SUBJECT: Forwards results of Westinghouse rept re boron injection tank (BIT) concentration/elimination study, in support of request to reduce BIT boron concentration to 0 ppm. Change would eliminate heat tracing, reducing maint costs.

SHEARON HARRIS NUCLEAR POWER PLANT
UNIT NO. 1 - DOCKET NO. 50-400
BORON INJECTION TANK CONCENTRATION REDUCTION

RESULTS OF THE REPORT FOR THE
BIT CONCENTRATION REDUCTION/BIT ELIMINATION STUDY
FOR THE SHEARON HARRIS NUCLEAR POWER PLANT

1.4 ft² Steamline Rupture
Offsite Power Not Available

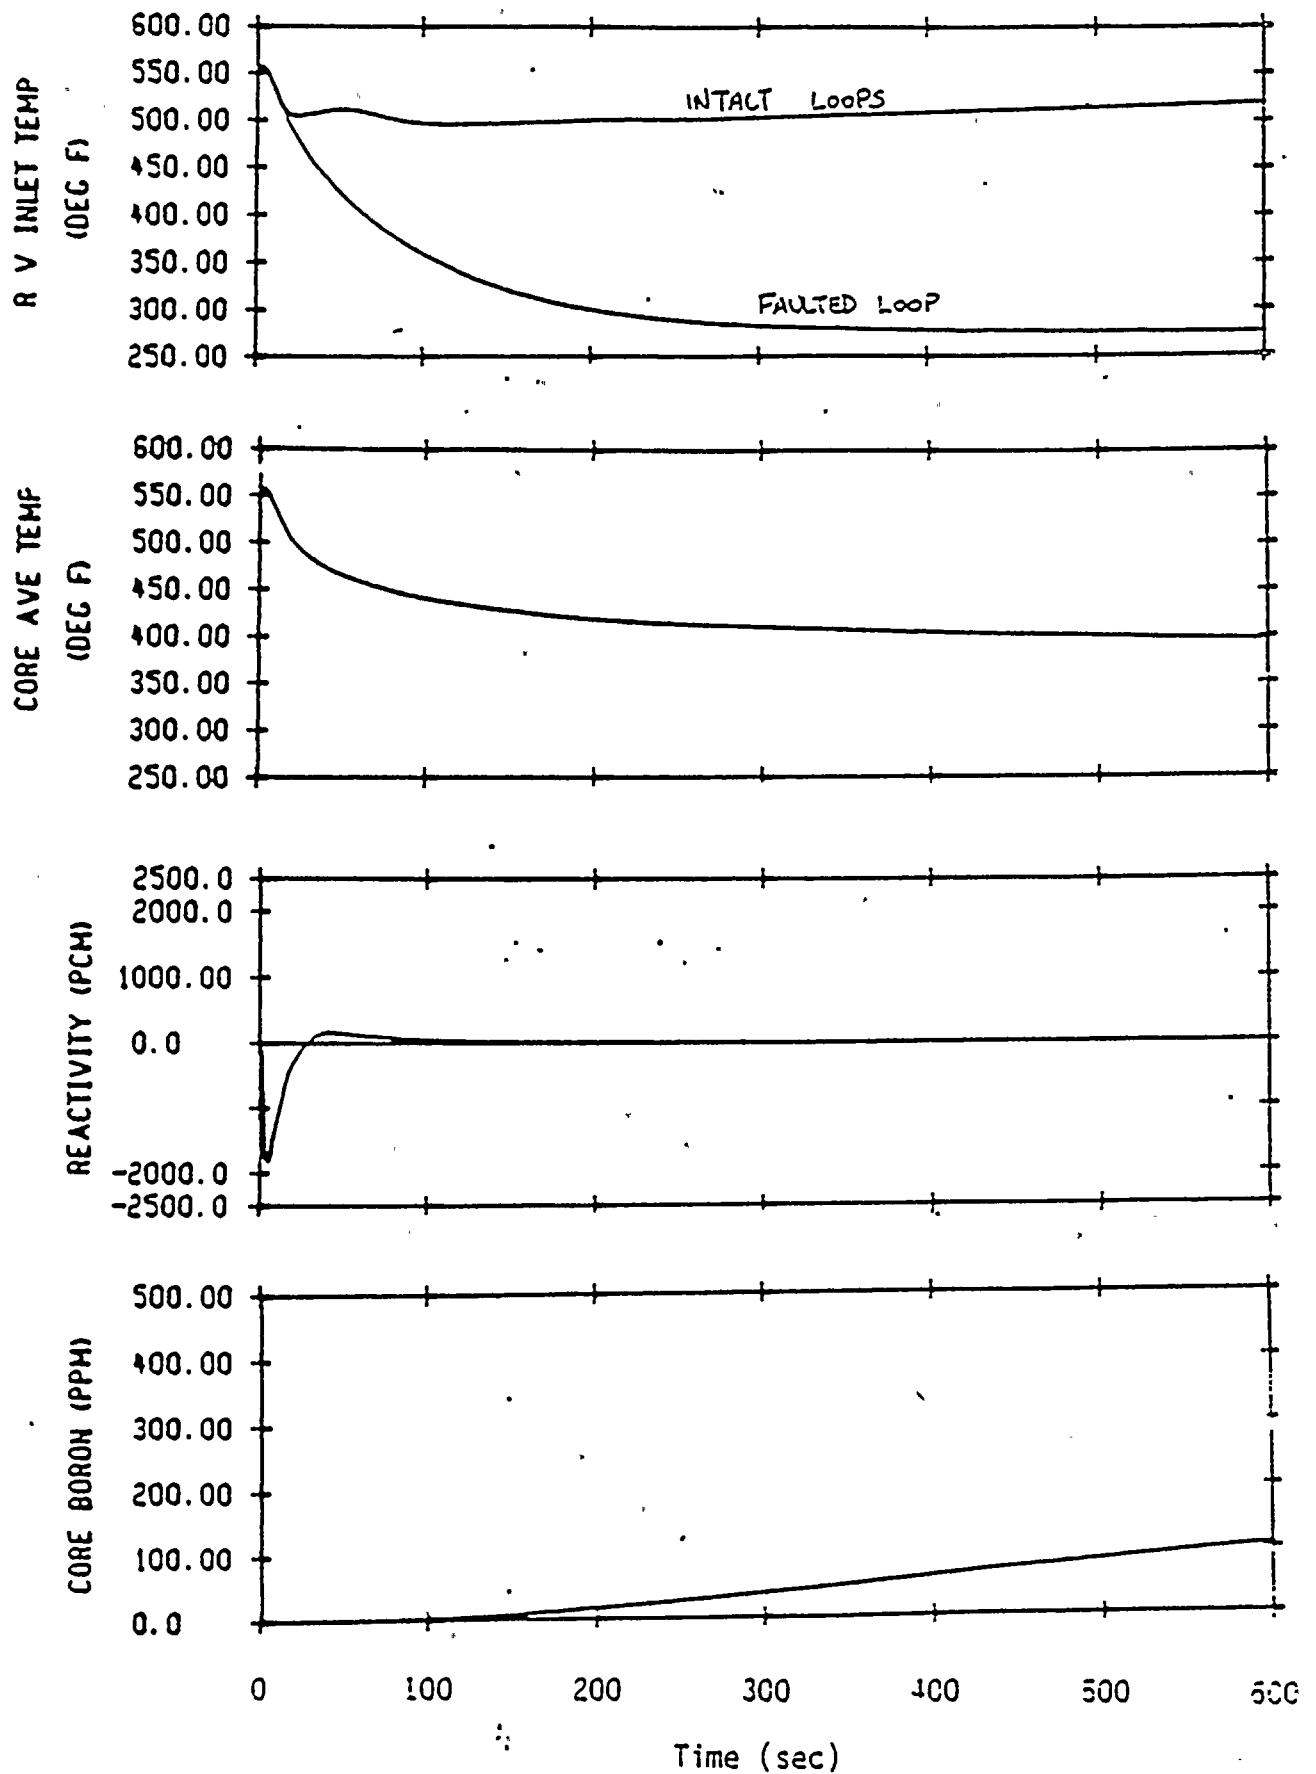
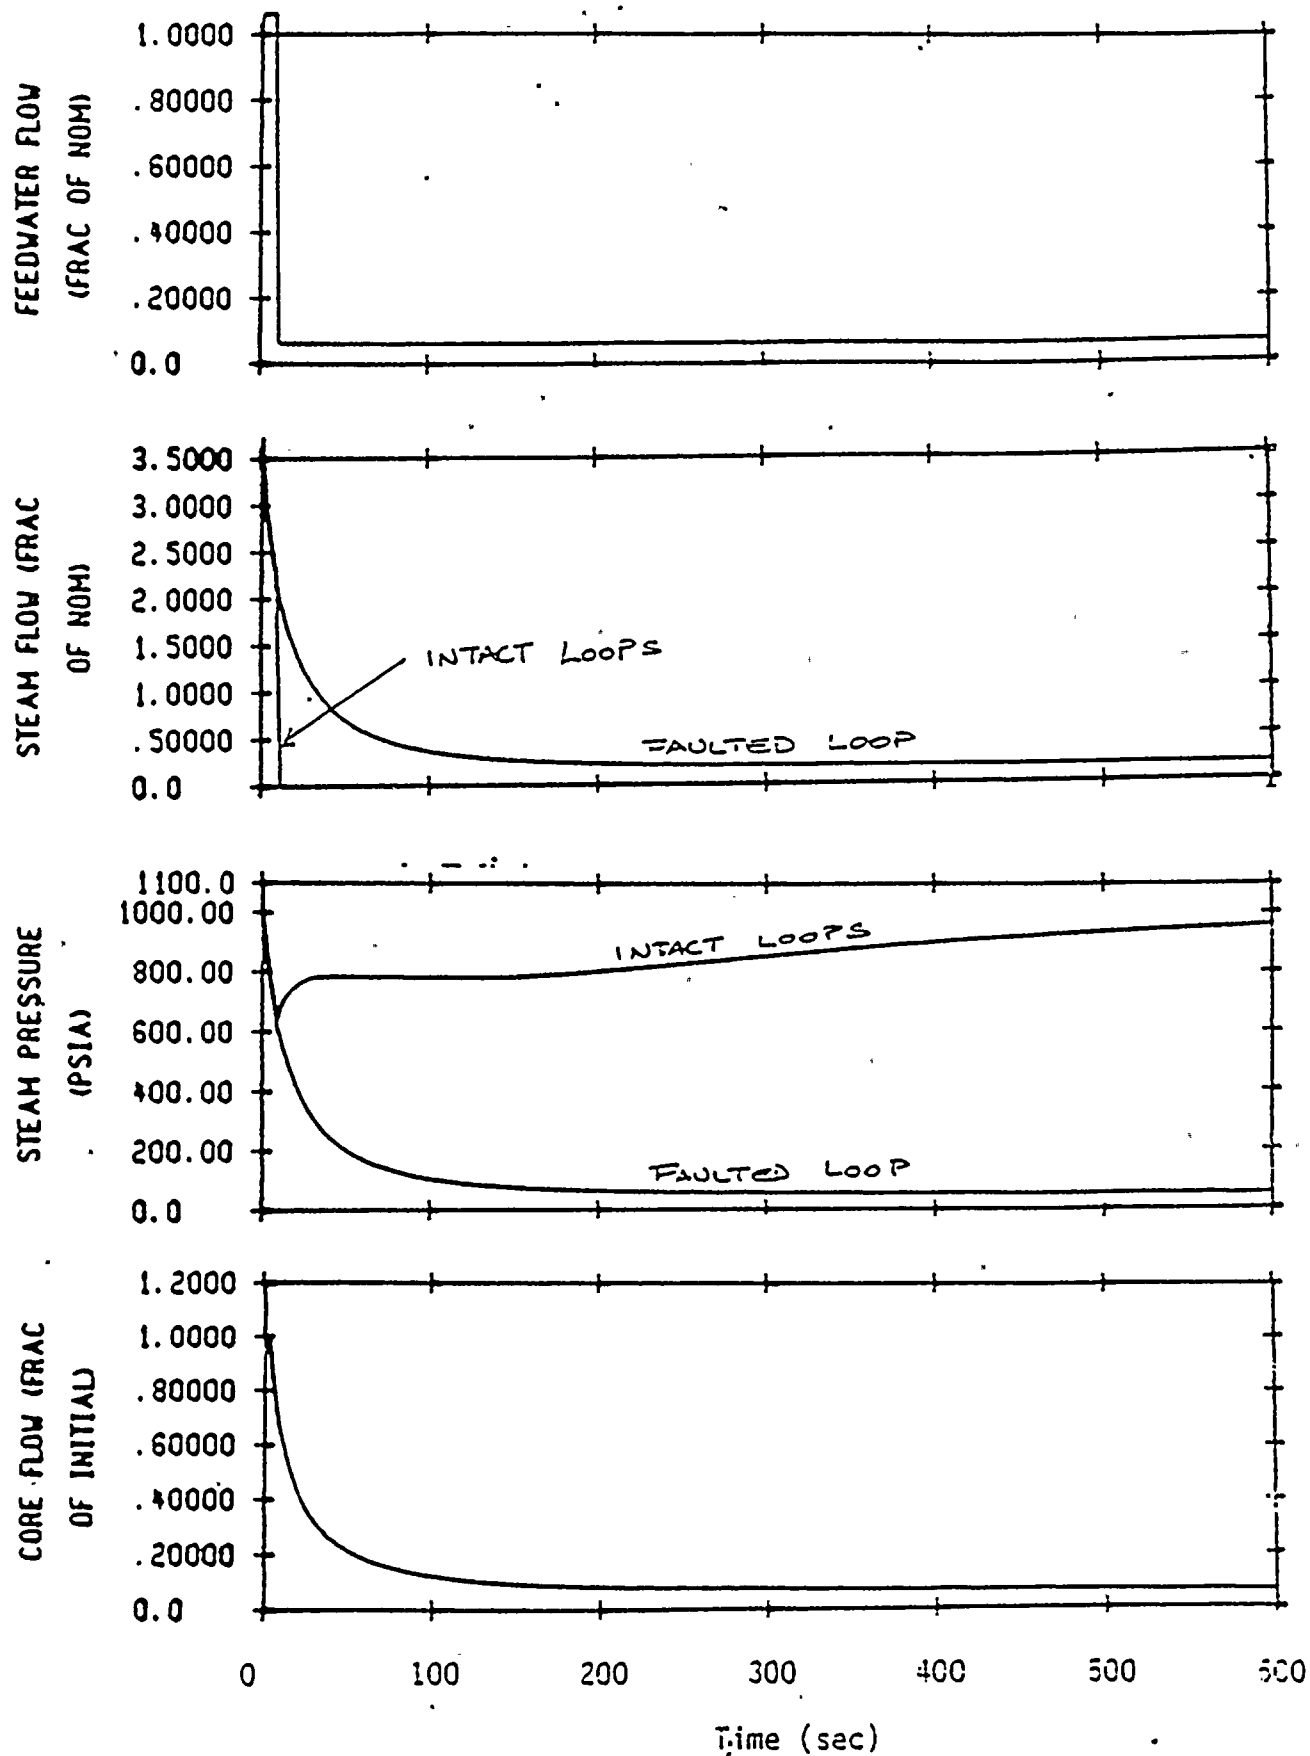
The attached Figures 1 through 6 show the transient behavior for the hypothetical breaks. A comparison of these figures with the current FSAR figures reveals only small changes in RCS parameters, with the single exception of core power, which is understandably higher for the cases without the BIT. The effect of the boron on the total reactivity is both delayed and damped in the attached figures because the Safety Injection System must purge more water before injecting boron in the cold leg and the fact that the boron source (RWST) is both colder and of a lower boron concentration. This causes the power to initially rise to a higher peak due to the delay and to subsequent decay at a slower rate after the boron reaches the core. Additionally, with the BIT assumed to be at zero ppm concentration, the BIT acts as a dilution volume for the borated water being injected from the RWST, thereby further delaying the effectiveness of the RWST.

FIGURE 15.1.4-2

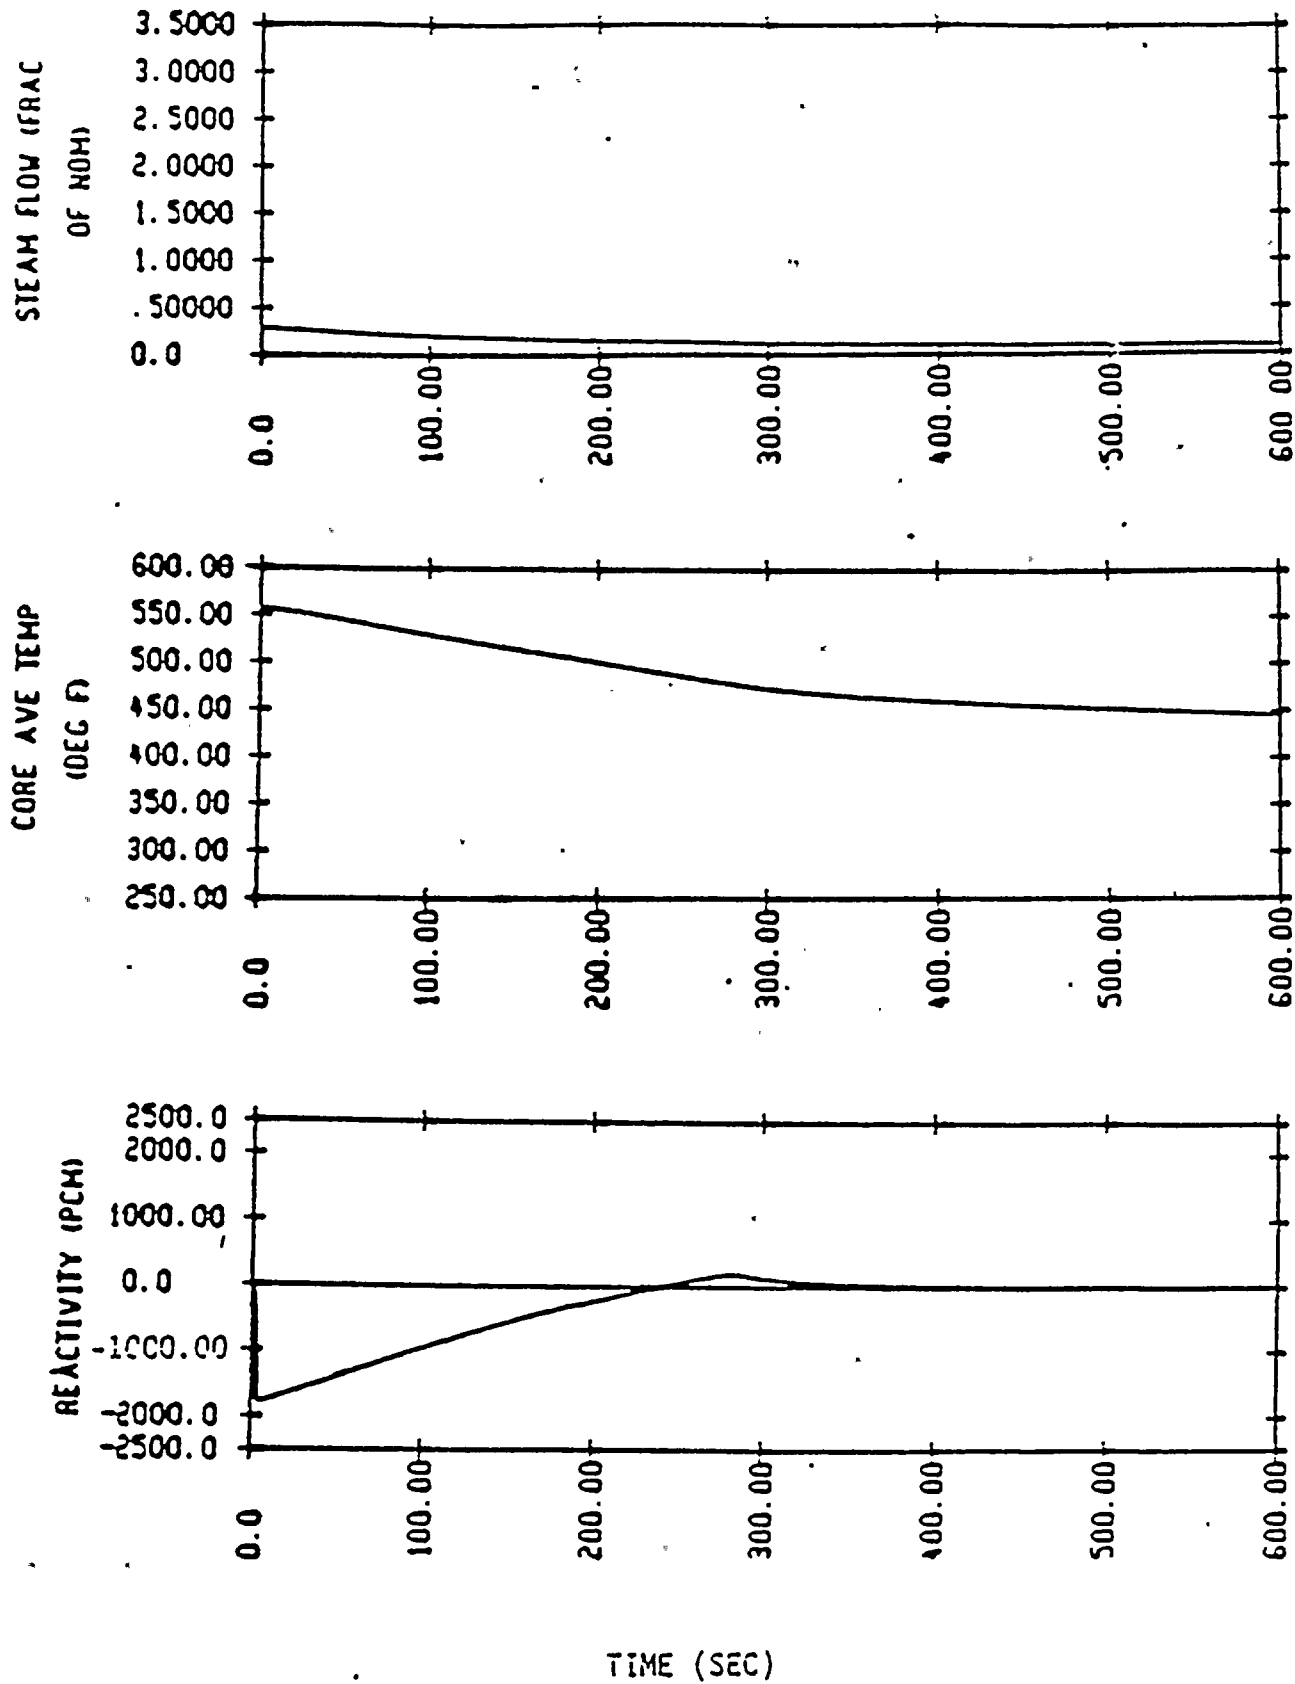
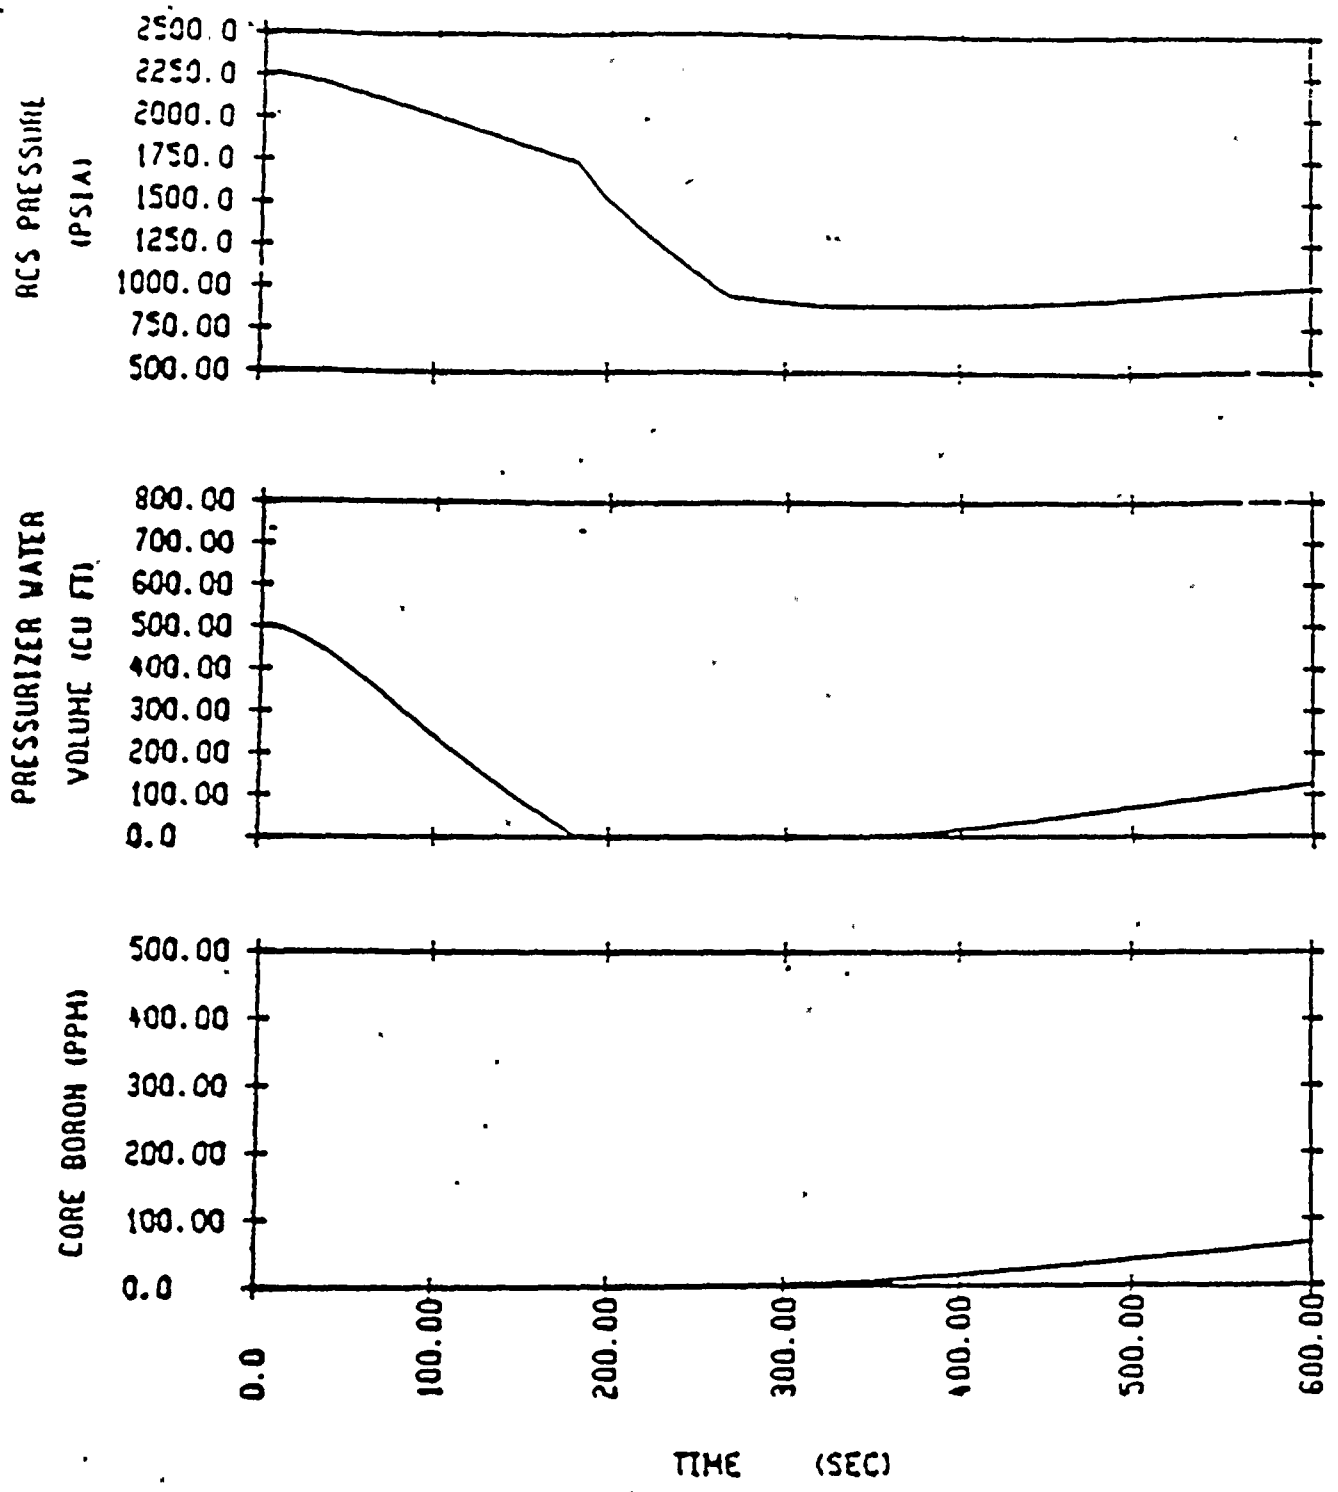
Attached Figures 7 and 8 depict system transient parameters for the Condition II steamline break in the FSAR. This Westinghouse criterion assures that the DNB design basis is met in a very conservative manner. In order to substantiate reduction of the boron concentration in the BIT, the Westinghouse criterion was relaxed to allow a subsequent return to power for the Condition II transients, but in order to meet the 10 CFR 20 dose requirements, the DNB design basis had to be met. Figure 7 shows that criticality is attained for the assumed BIT elimination. DNB analyses for this case show that the DNB design basis is met and no fuel failures are predicted. This conclusion is also consistent with the conclusion drawn on the Condition IV breaks, since no violation of the DNB design basis was calculated for the more extreme Condition IV, double-ended ruptures.
